ADDENDUM NO. 3

November 11, 2022

LIBERTY ELEMENTARY SCHOOL RENOVATIONS Chesterton, IN 46304

A-610

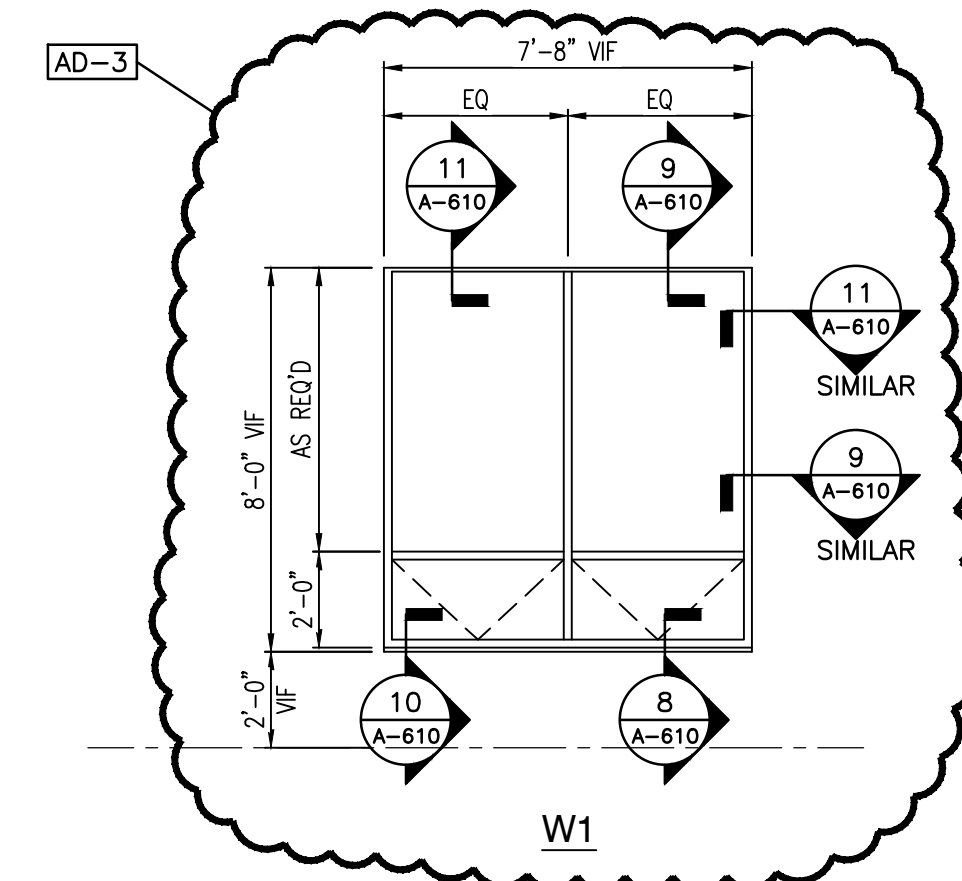
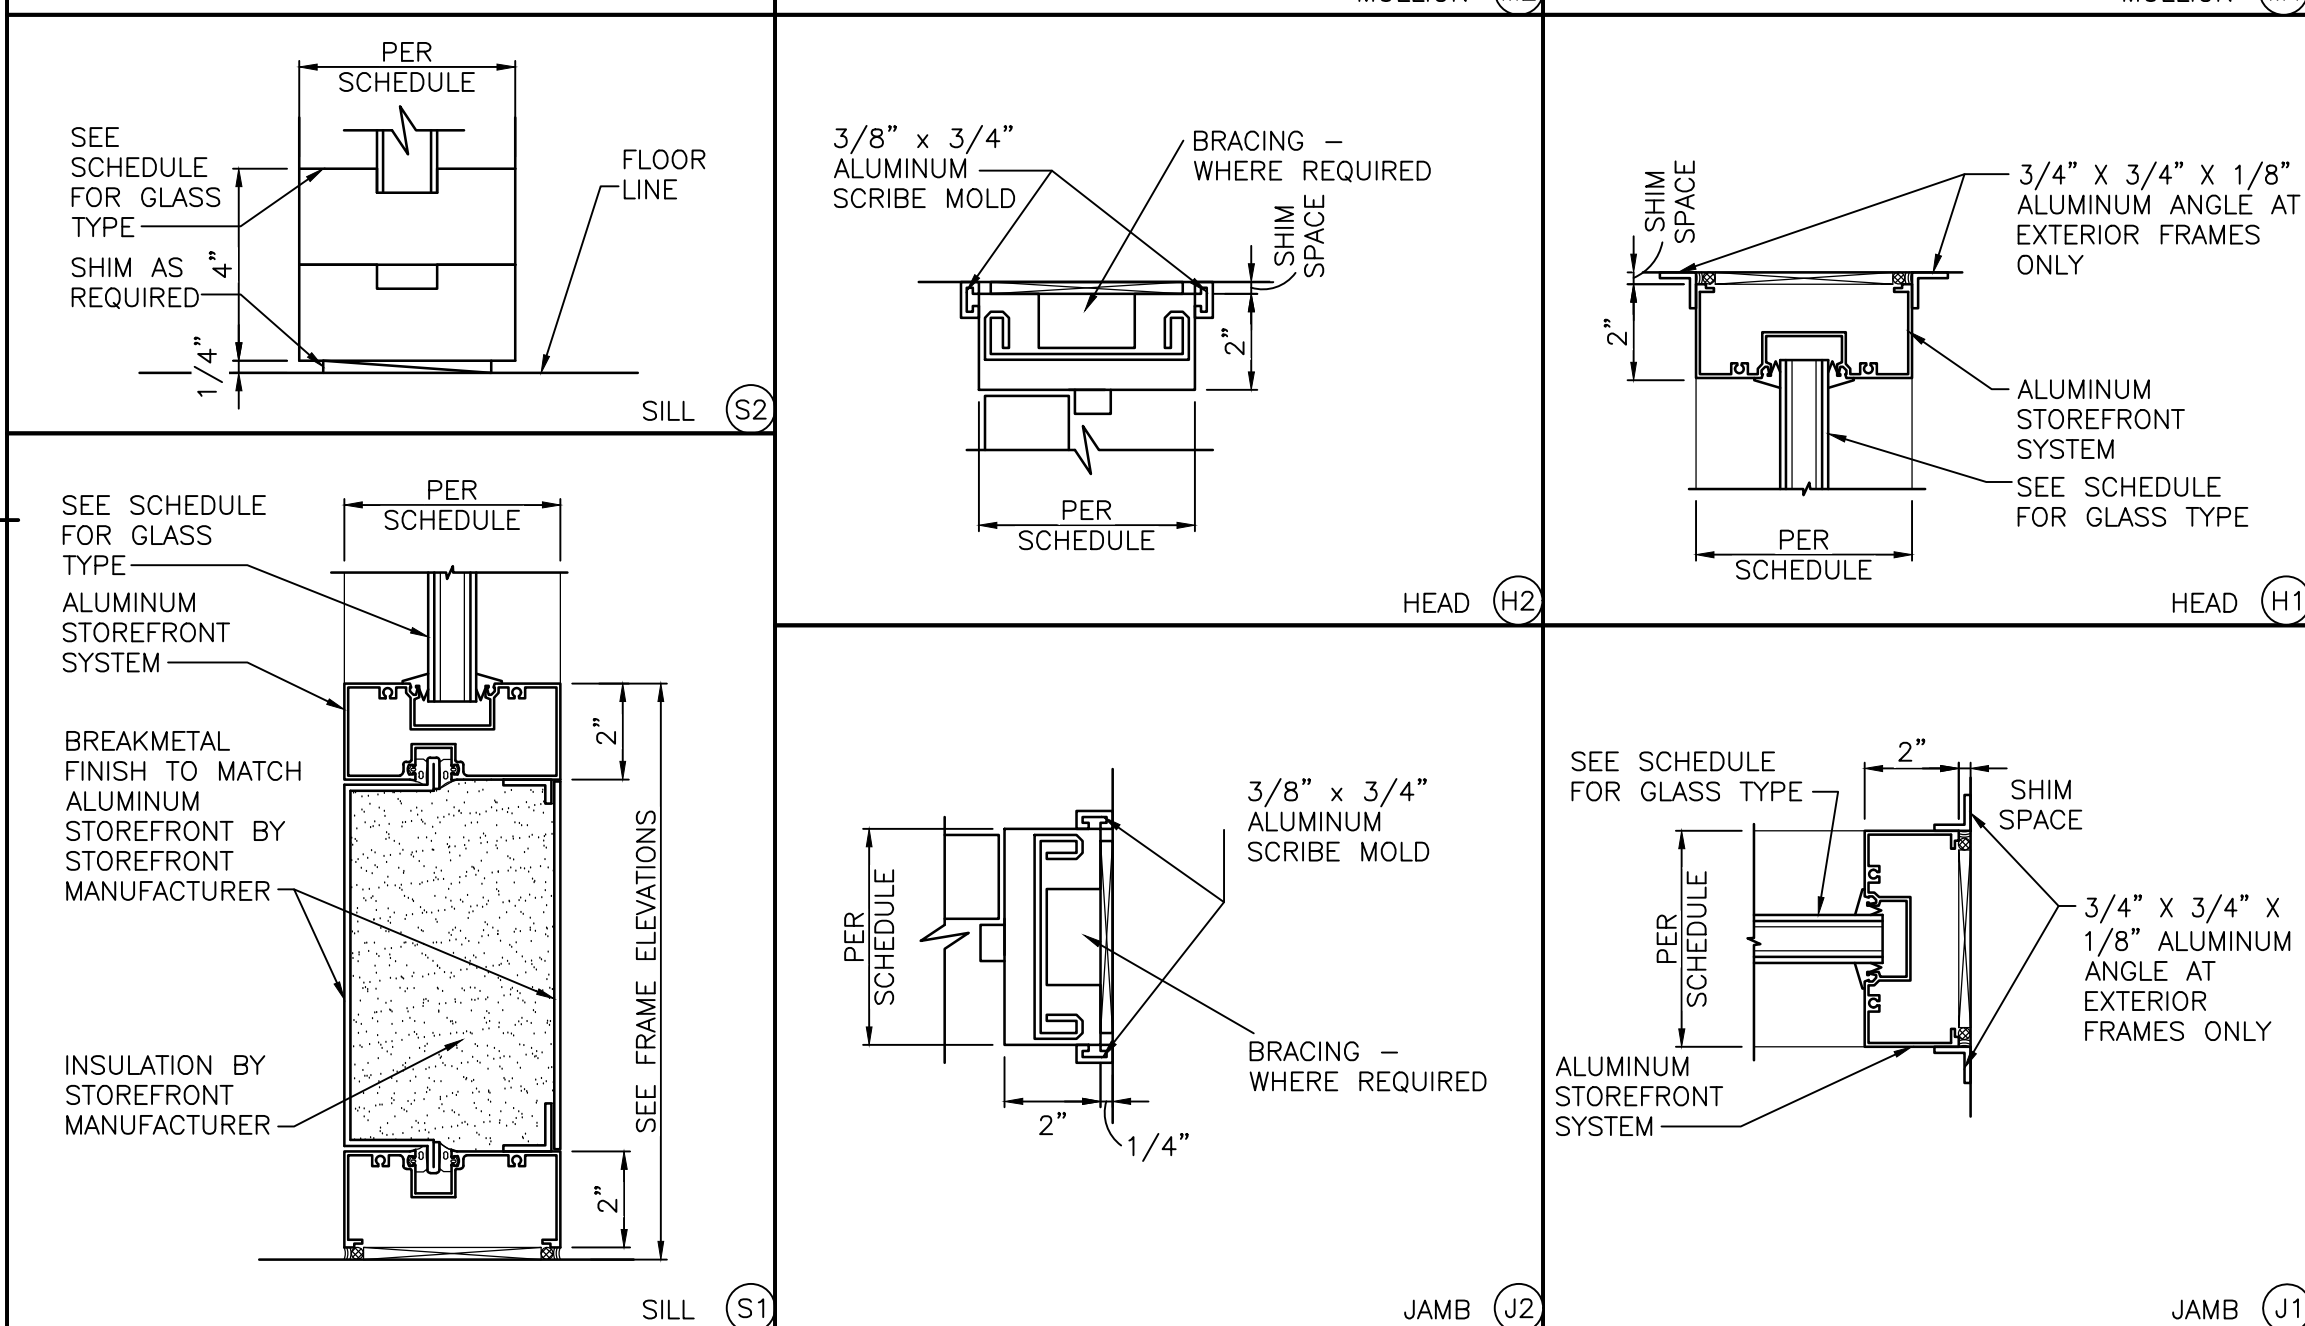
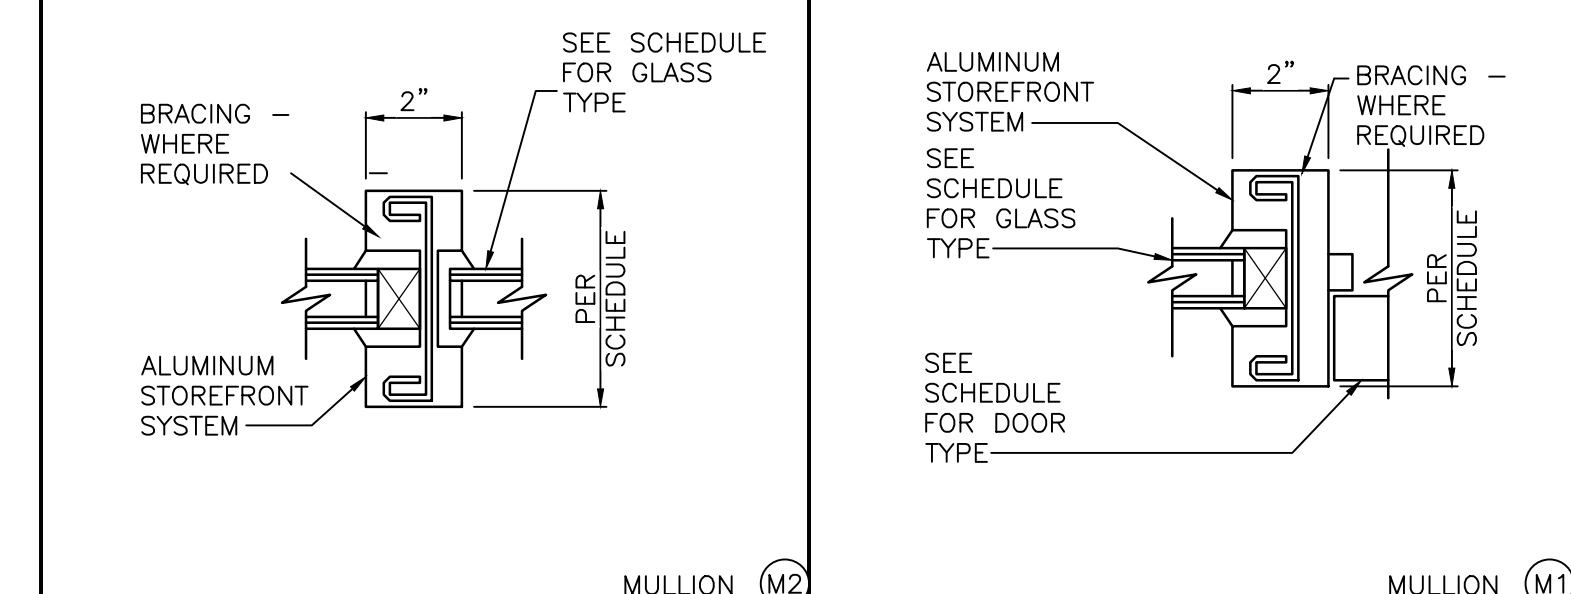
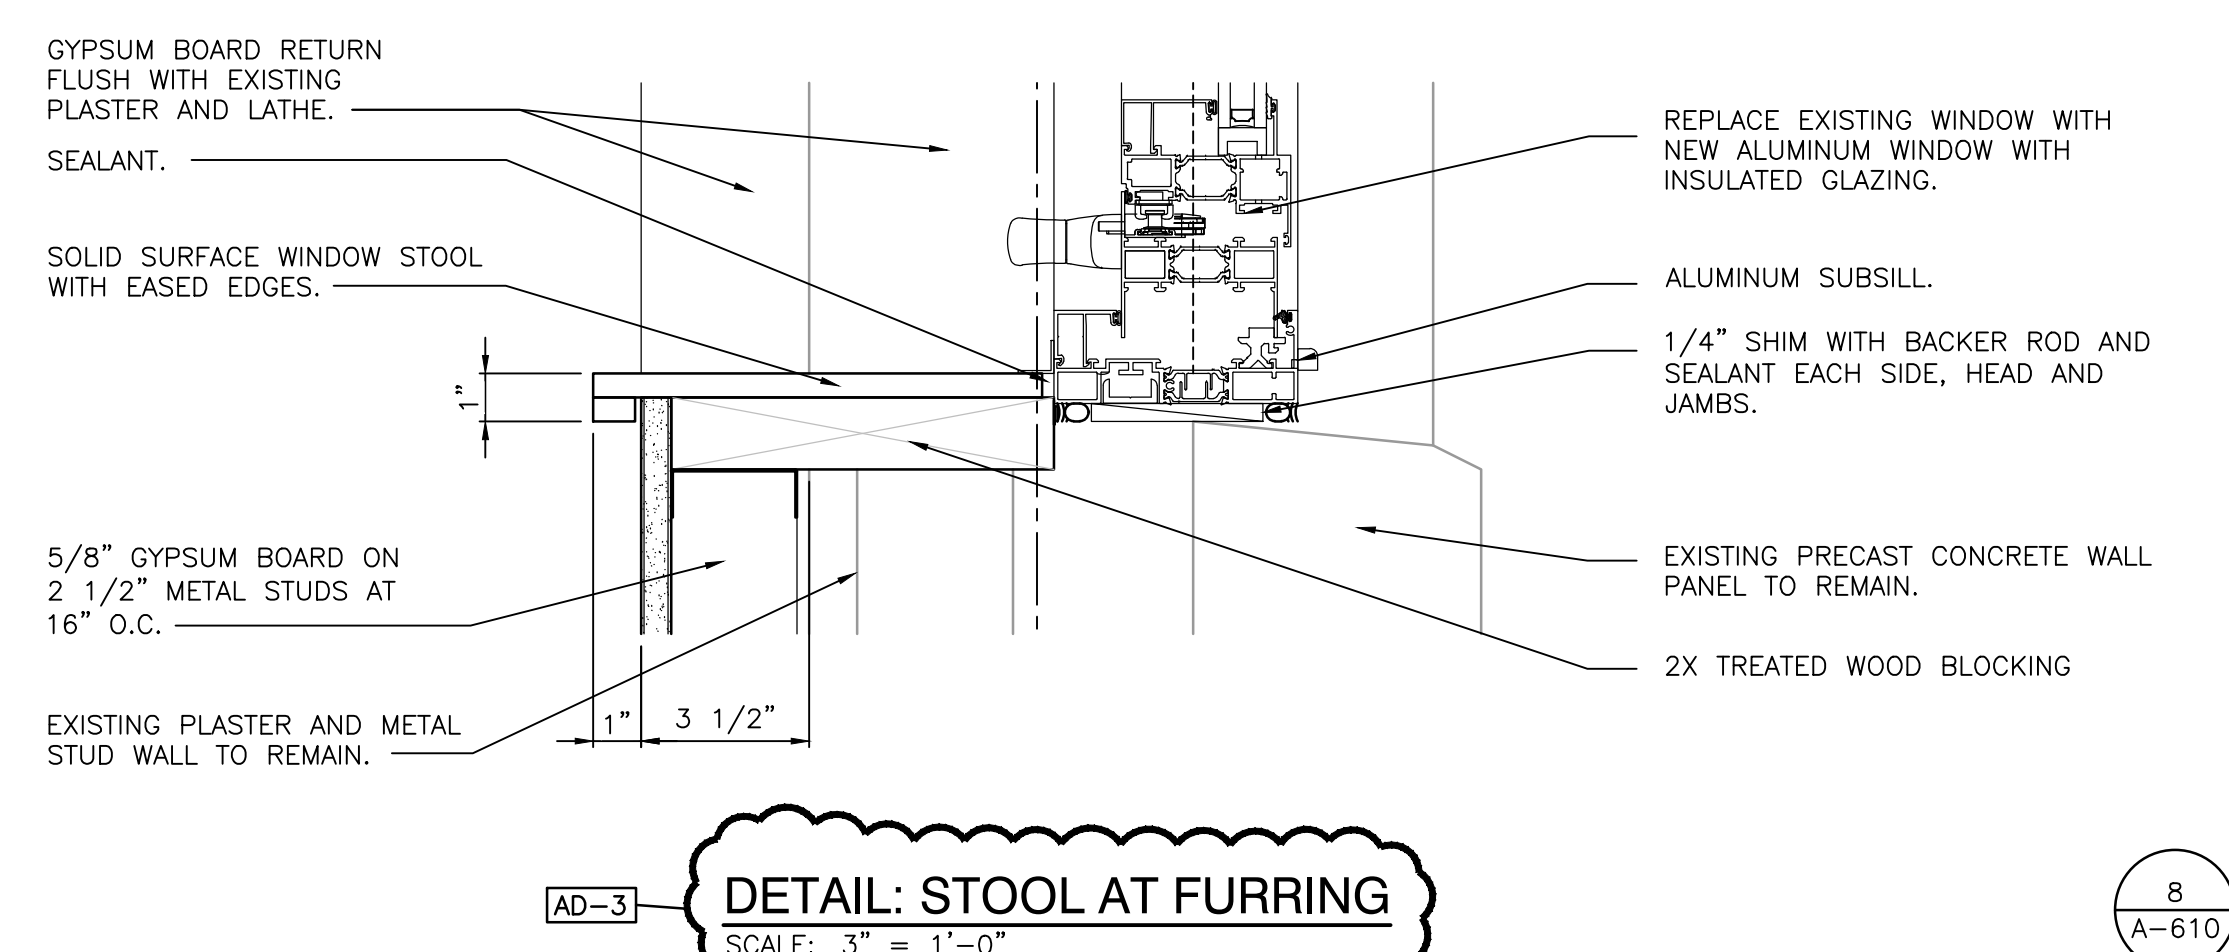
1. Add additional section cuts to Aluminum Window Elevation W1.
2. Revise titles of Detail 8 and 9/A-610.
3. Add Details 10 and 11/A-610 for windows in existing wall construction without new wall furring.
